TOWN OF LOXAHATCHEE GROVES
TOWN HALL CHAMBERS
PLANNING AND ZONING BOARD AS LOCAL PLANNING AGENCY

August 25, 2022 – 5:30 P.M.

AGENDA ITEM STAFF SUMMARY: VARIANCE APPLICATION VA-2022-01

**Site Plan Amendment Application SPA 22-01
Southern Lawn Equipment (a.k.a. Drysdale Property; Valencia Village)**

EXHIBIT 1 – PROPOSED COLOR ELEVATIONS

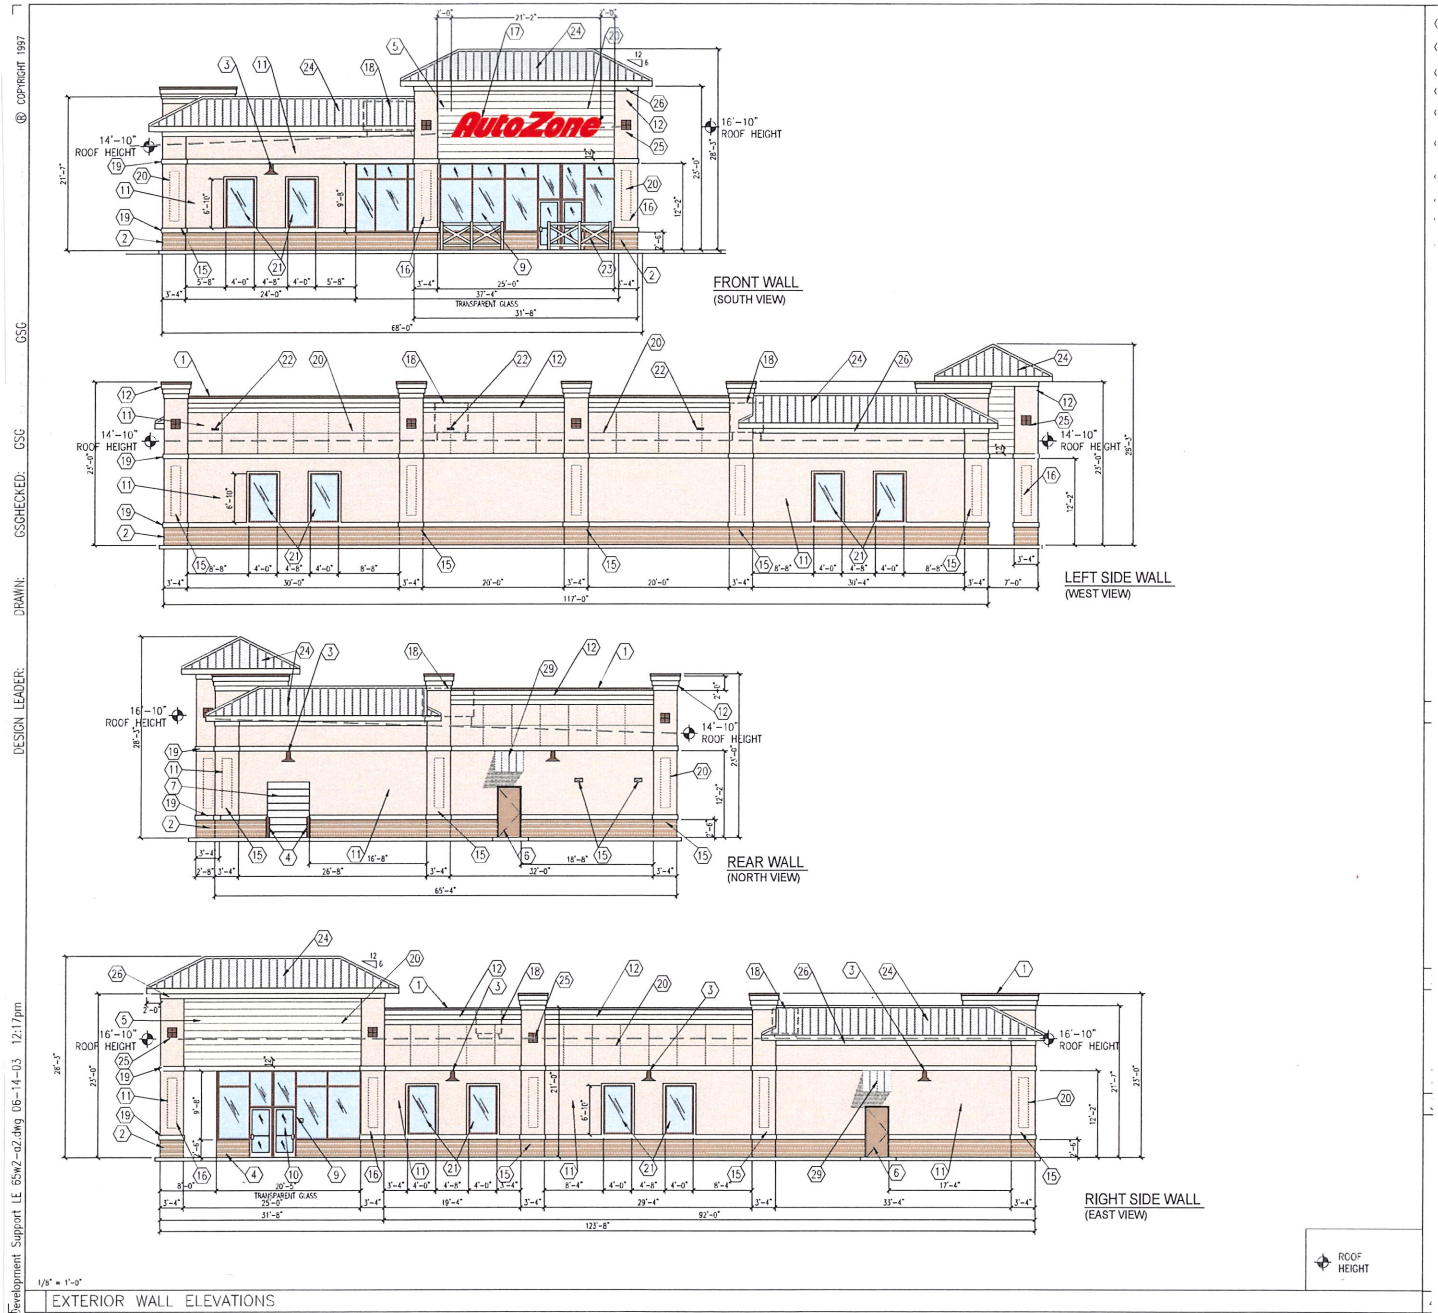
The Applicant has requested that the sign face of AutoZone building wall sign be increased from a maximum of 36 square feet to 74 sq. ft. facing Southern Boulevard; a sign face variance of 38 sq. ft. or 106%. Refer to Exhibits 1 and 2 for proposed sign design.

The requested variance is to allow a building within a multi-tenant center (i.e. Pod A – Wawa/AutoZone/Aldi) to exceed the maximum sign-face area for the allowed primary wall sign. Per ULDC Section 90-040(B) (3) b., the sign-face maximum is 36 sq. ft. for the Primary Sign. The Applicant has proposed 74 sq. ft. to be permitted.

The Applicant has made valid observations regarding visibility, safety and wall sign approvals in commercial projects along Southern Boulevard. It is concluded that the Applicant has demonstrated, by competent and substantial evidence, that each of five review criteria in ULDC Section 150-020, as required by code, has been met. Based upon this conclusion, Staff recommends approval of Variance Application VA- 22-01 to increase the size of the Primary Wall sign to a maximum of 74 sq. ft., as illustrated on Exhibits 1 and 2.

EXHIBIT 1 – PROPOSED WEST ELEVATION WALL SIGN

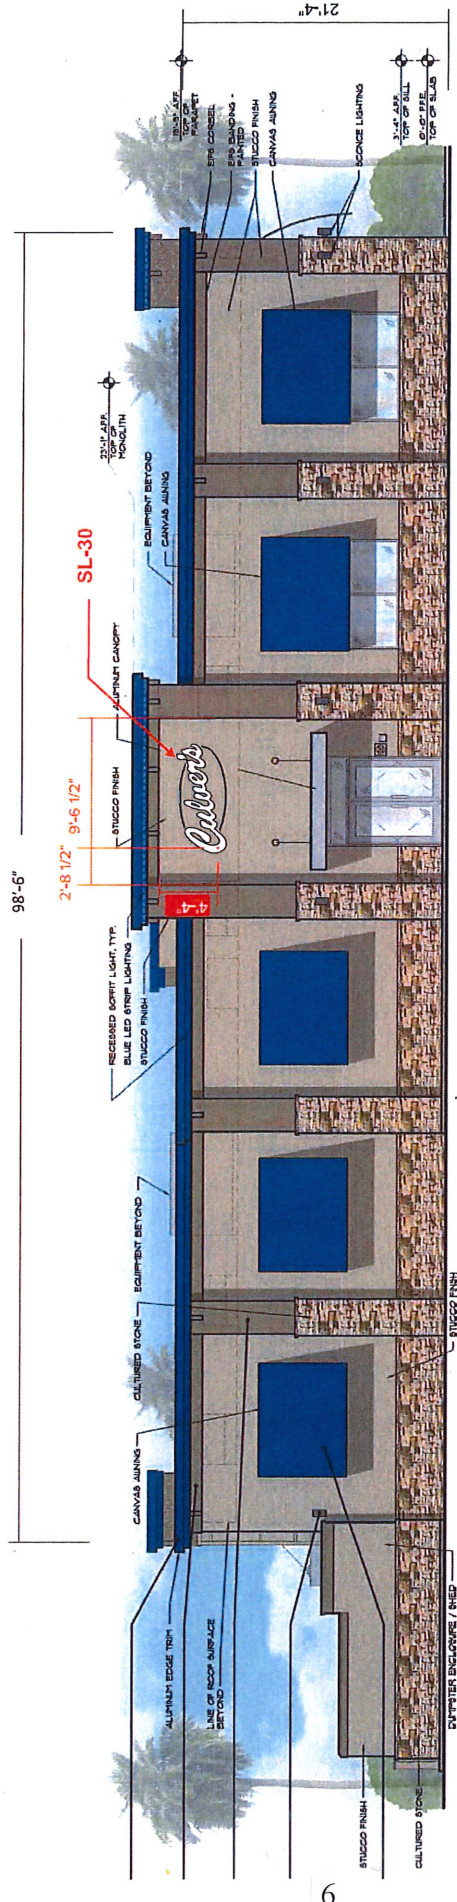
Specifically, the Applicant has requested variance approval to allow a west elevation building wall sign of 29.96 square feet and a menu board sign of 24 sq. Refer to Exhibits 1 - 3 for proposed sign illustrations.

ULDC Section (B) (3) b states that one wall sign is permitted unless a building is located at a street corner where a second sign is permitted. As the Culvers Restaurant is not located at a corner, a second wall sign is currently not permitted. The requested wall sign variance is to allow a second wall sign of 29.96 sq. ft. on the west building elevation (Refer to Exhibits 1 and 2).

Staff Analysis: The Applicant stated that a Secondary Wall Sign is needed to provide visibility for customers in terms of location of the standard entrance to the restaurant. Primary Wall Signs are allowed up to 36 sq. ft. by the ULDC while the Applicant is requesting a Secondary Wall Sign of 29.96 sq. ft.

It is concluded that the Applicant has demonstrated, by competent and substantial evidence, that each of five review criteria in ULDC Section 150-020, as required by code, has been met. Based upon this conclusion, Staff recommends approval of Variance Application VA- 22-02 permitting a Secondary Wall Sign of 29.96 sq. ft. on the west elevation and a Menu board of 24 sq. ft.

EXHIBIT 3 – PROPOSED MENU BOARD DESIGN SPECIFICATIONS

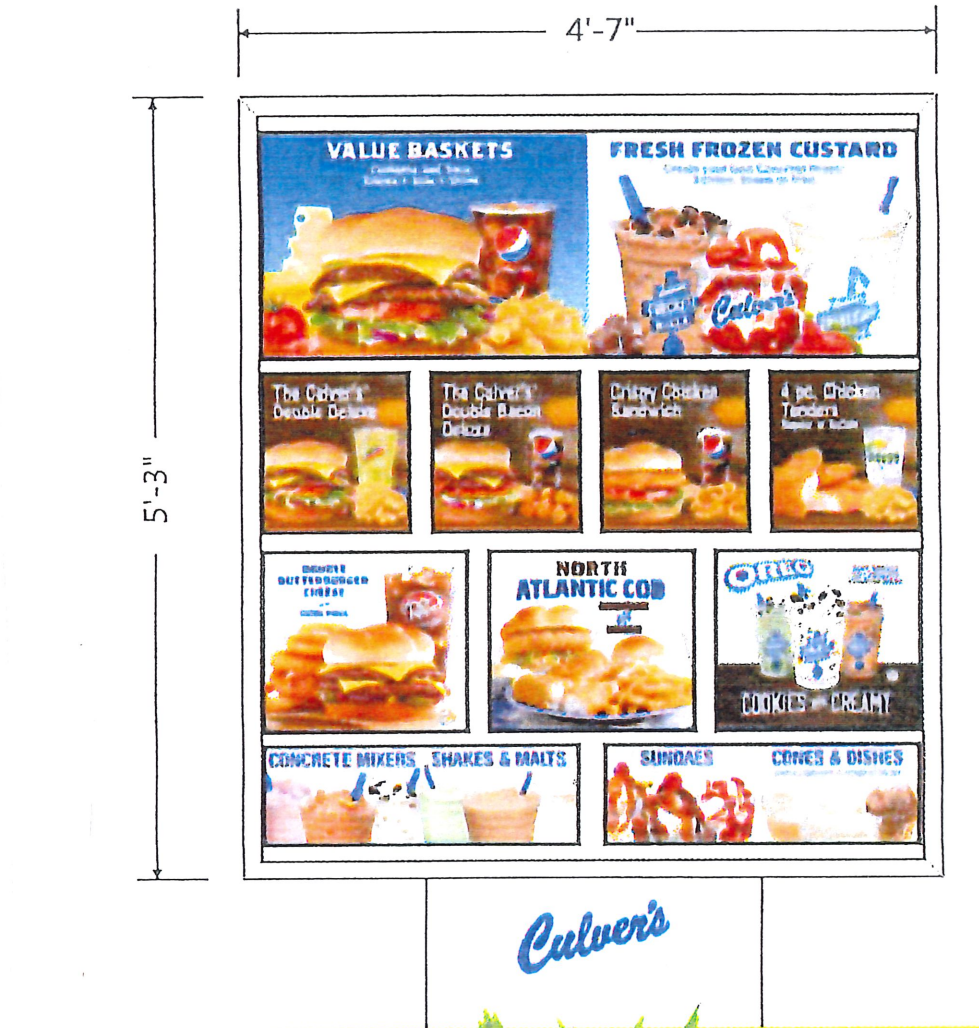
ULDC Section 90-040(B)(5)b states that a drive-thru (panel sign) is permitted on a building of 1,000 sq. ft. or more with a maximum face area of no greater than 12 sq. ft.. The requested panel sign variance is to allow a drive-thru menu board of 24 sq. ft. (Refer to Exhibit 3).

The Applicant stated that Menu Board proposed size of 24 sq. ft., less than the industry standard of 50 sq. ft., is needed to inform customers of the food offering. Menu Boards are allowed up to 12 sq. ft. by the ULDC while the Applicant is requesting a sign approval of 24 sq. ft.

EXHIBIT 2 – FDOT COMPENSATION STORAGE POND

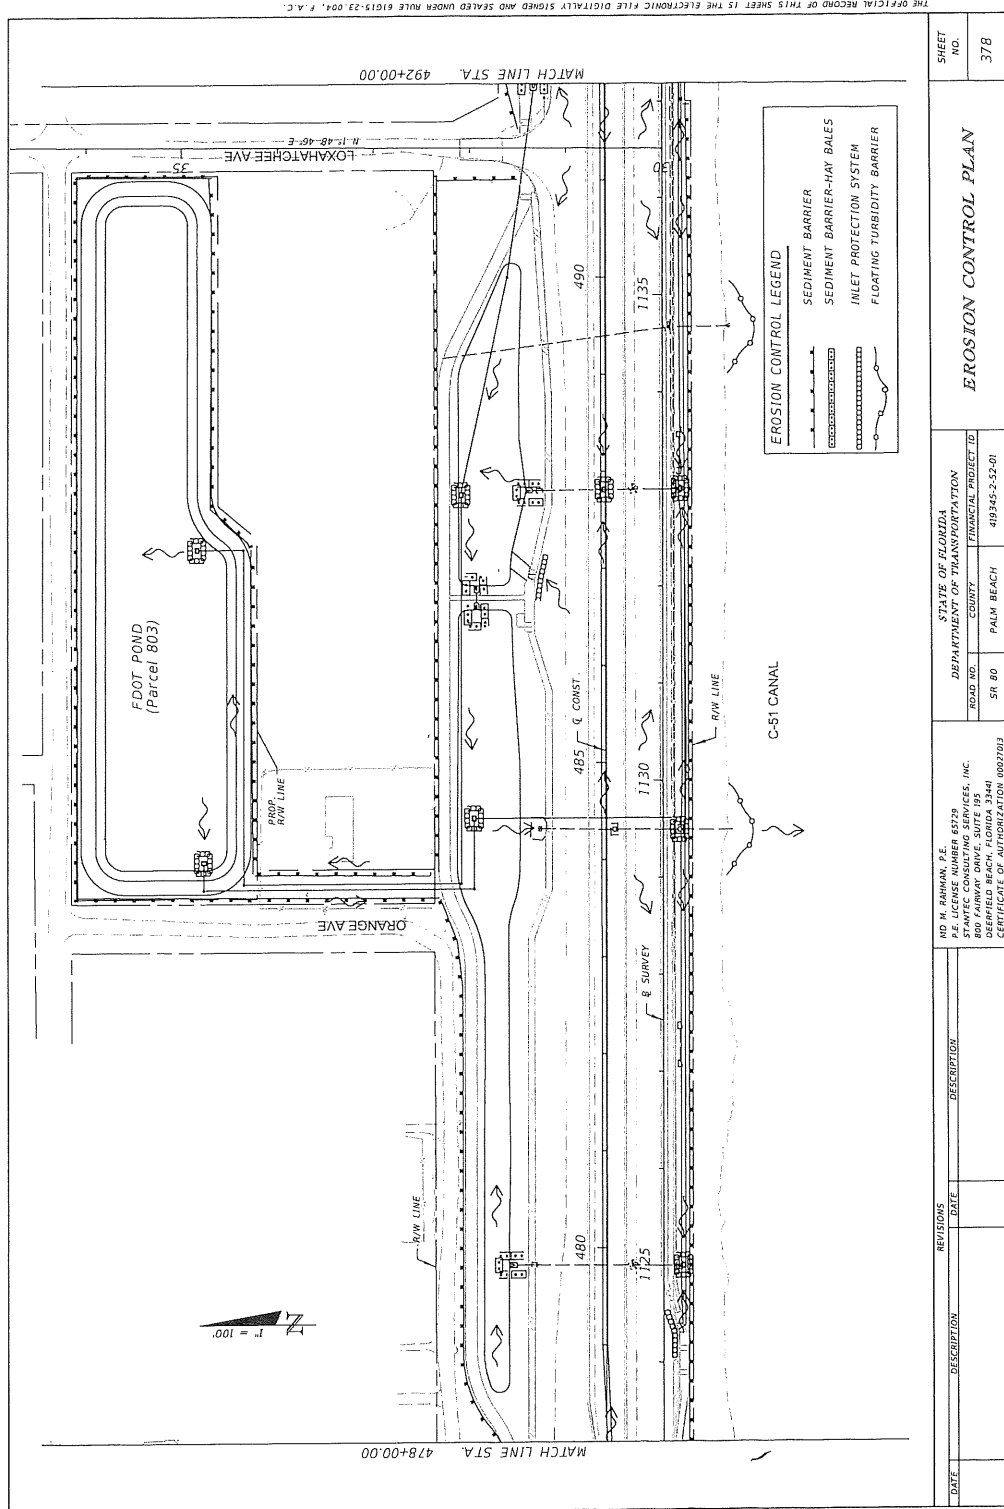
After site plan approval by the Town Council, a 3.032 acre portion of the property was identified by the Florida Department of Transportation (FDOT) as a preferred location for a compensation pond to accommodate additional stormwater runoff from the Southern Boulevard expansion. A Perpetual Easements (O.R.B. 29172 Pages 1040 - 1048) was executed between FDOT and the previous owner to implement the drainage concept illustrated on Exhibit 2. The 3.032 acre area has not been deducted from the 6.55 acre site area for the purposes of calculating buildable area (i.e. the 0.1 F.A.R. maximum is still applied to the entire 6.55 acre site to determine maximum buildable space).
